Public Hearing Appeal Submission

LOC2024-0183

(DP2024-06339, 206, 210, 214, 218 19 Street NW)

Subject Site - West Nineteenth
 Lane

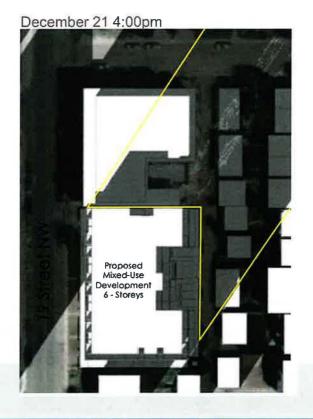
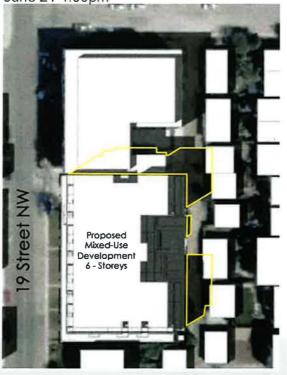
- The massing shifts and cutouts of this application are materially insignificant and do not provide sufficient transitions for shadowing impact
 - Shadow studies indicate a prevailing impact on the properties to the NE of the Application past 4pm
 - The proposed courtyard cut-out would need to be the full-width of the building to be effective in providing relief
 - ✓ 5th / 6th floor step backs are insufficient to achieving scale transitions

(above) Cross-section of Application showing failure to step back at the 3rd storey and the immaterial stepbacks / massing shifts creating insensitive transitions to the adjacent 18A St NW properties

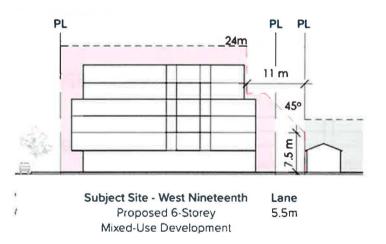
This Application breaches specific guidance re 19th Street NW development guidelines in the Riley LAP regarding scale transitions (step-backs in particular)

d. Development that shares a property line or lane with parcels developed with single detached, semi-detached, or duplex residential development should step back the building above the <u>third storey</u> along the shared property line with the lower density development.

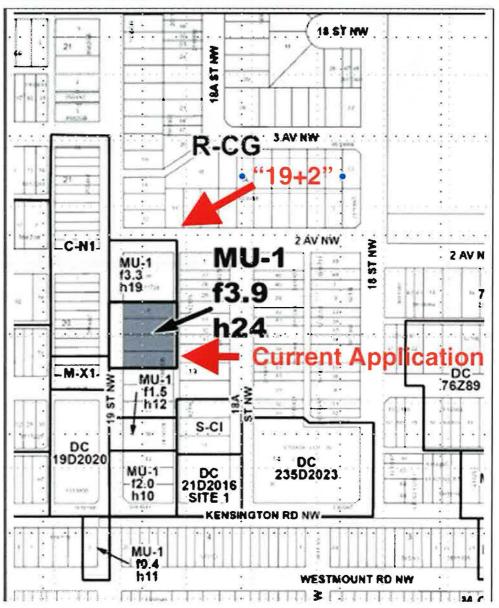
- The Applicant's previous "19+2" building immediately to the north of this Application is at 19 metres of height and the current land use is 19 metres
- The middle three parcels are designated R-CG and the building height is 11 metres
- The new development at the south part of the block is at 12 metres and the shopping centre at Kensington Road is at 10 metres
- Any additional height should be at the south end of 19th St NW to complement the Legion re-development – and not be midblock
- The existing MU-1f3.3h19 land use is sufficient for high density development

There is no reason this land use should be at such a building height given its surroundings
